## SINGAPOREAN NOTICES TO MARINERS

**GSP1/SP1** 9 Ed 15/01/25 Last NM 68/2025 (Maritime and Port Authority of Singapore) **\*NM 77/2025**

CORRECTION NO.	SNM EDN NO.	LAST CORR N NO.	CHART NO.	Location on Chart		
77 & 78	09	68	GSP1/SP1	X

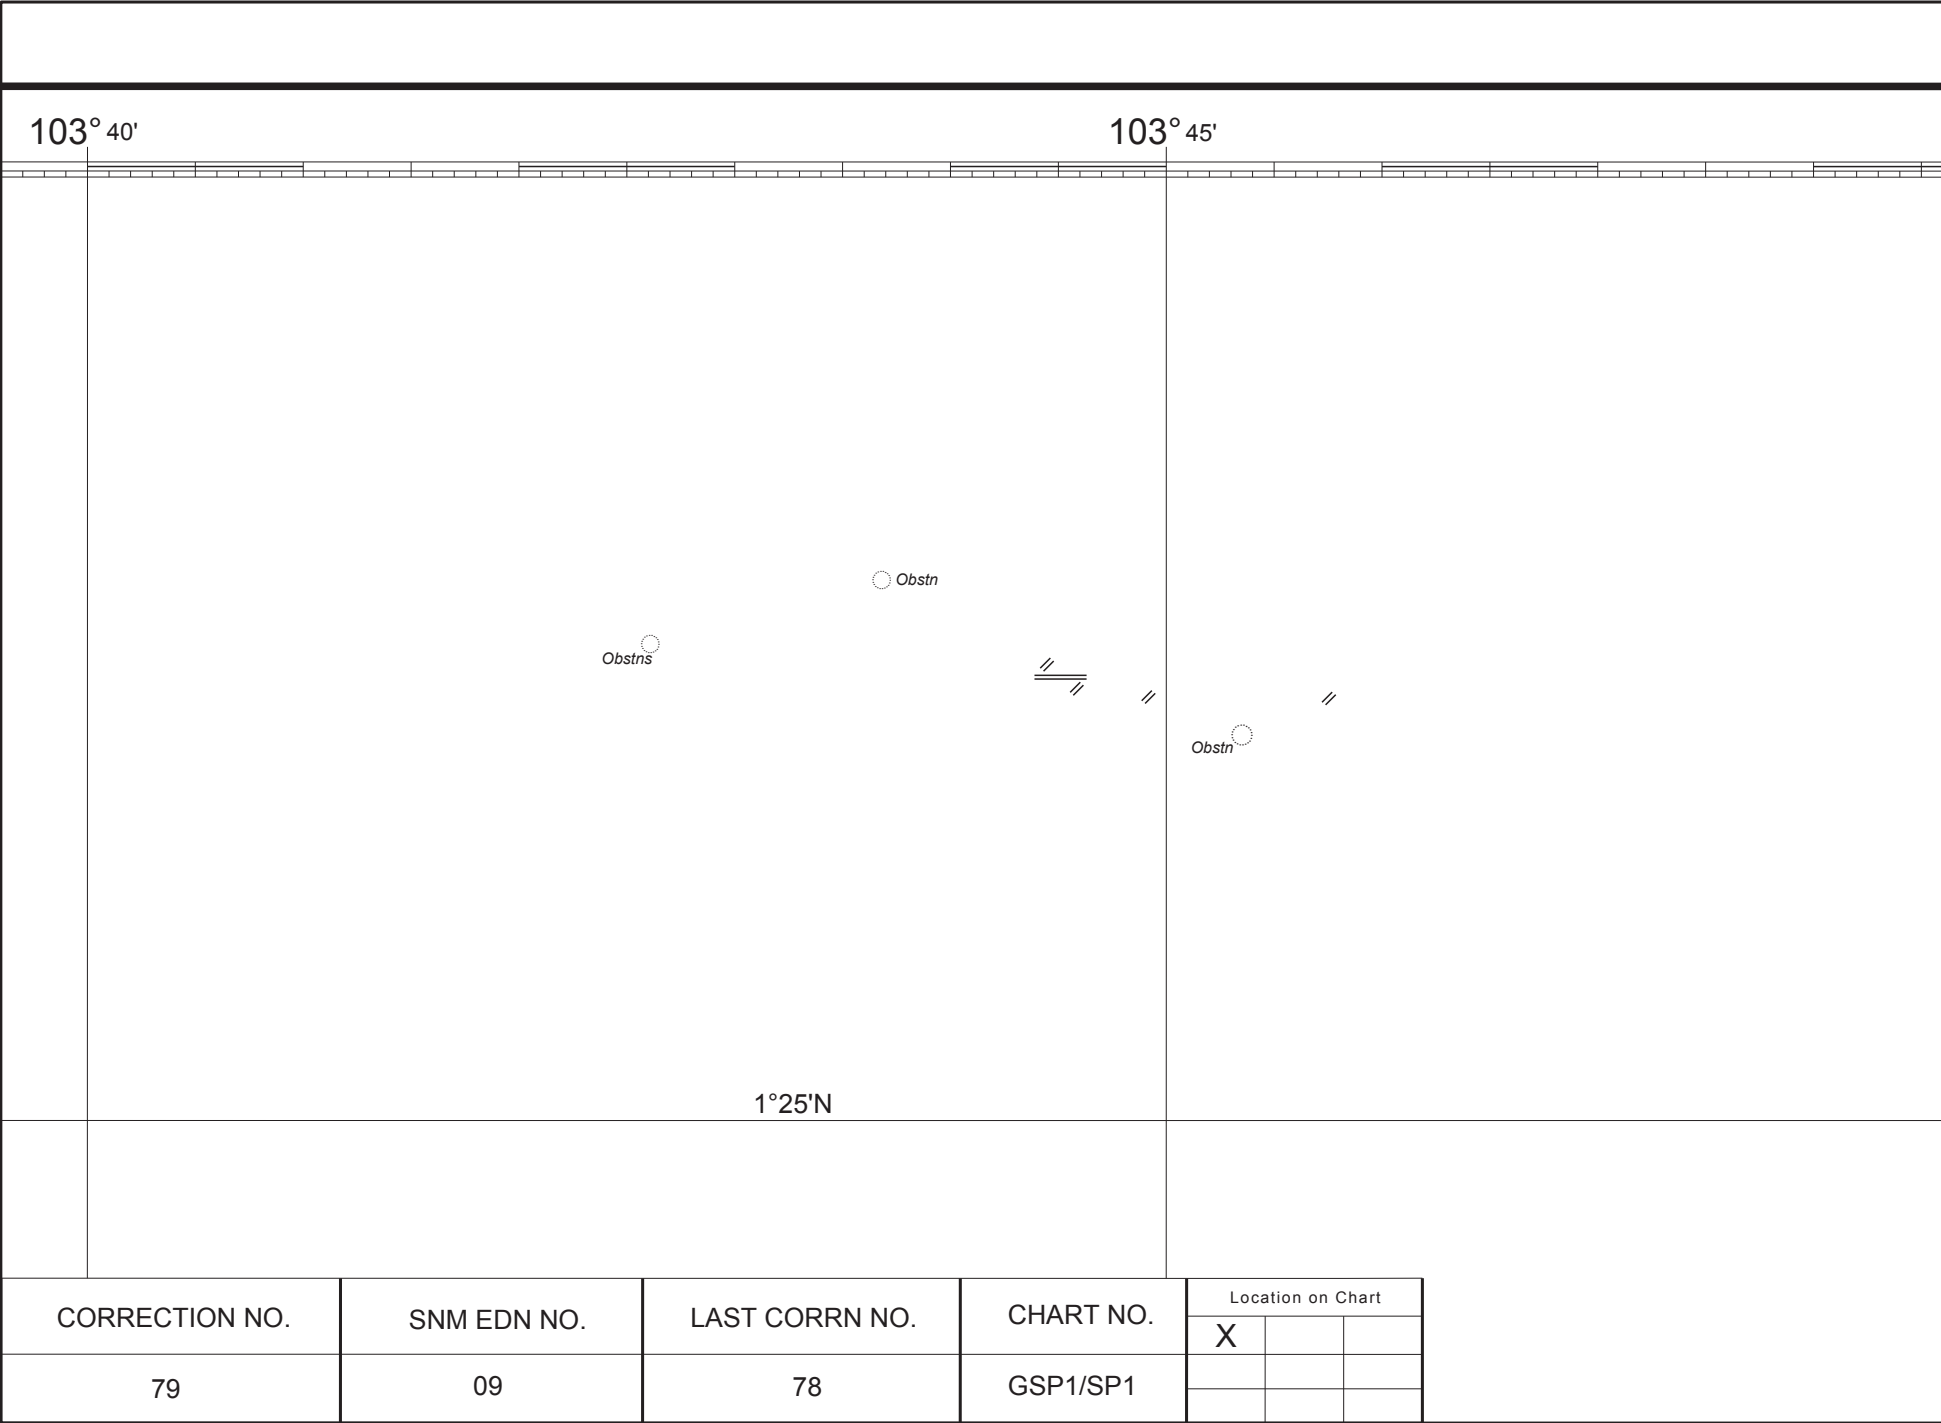
**Delete**  *HD TWC 9, Fl.Y.2s* 1°18·88'N 103°36·92'E

**Insert**  *DHI-NTB-01, Fl.Y.4s* 1°17·78'N 103°38·73'E
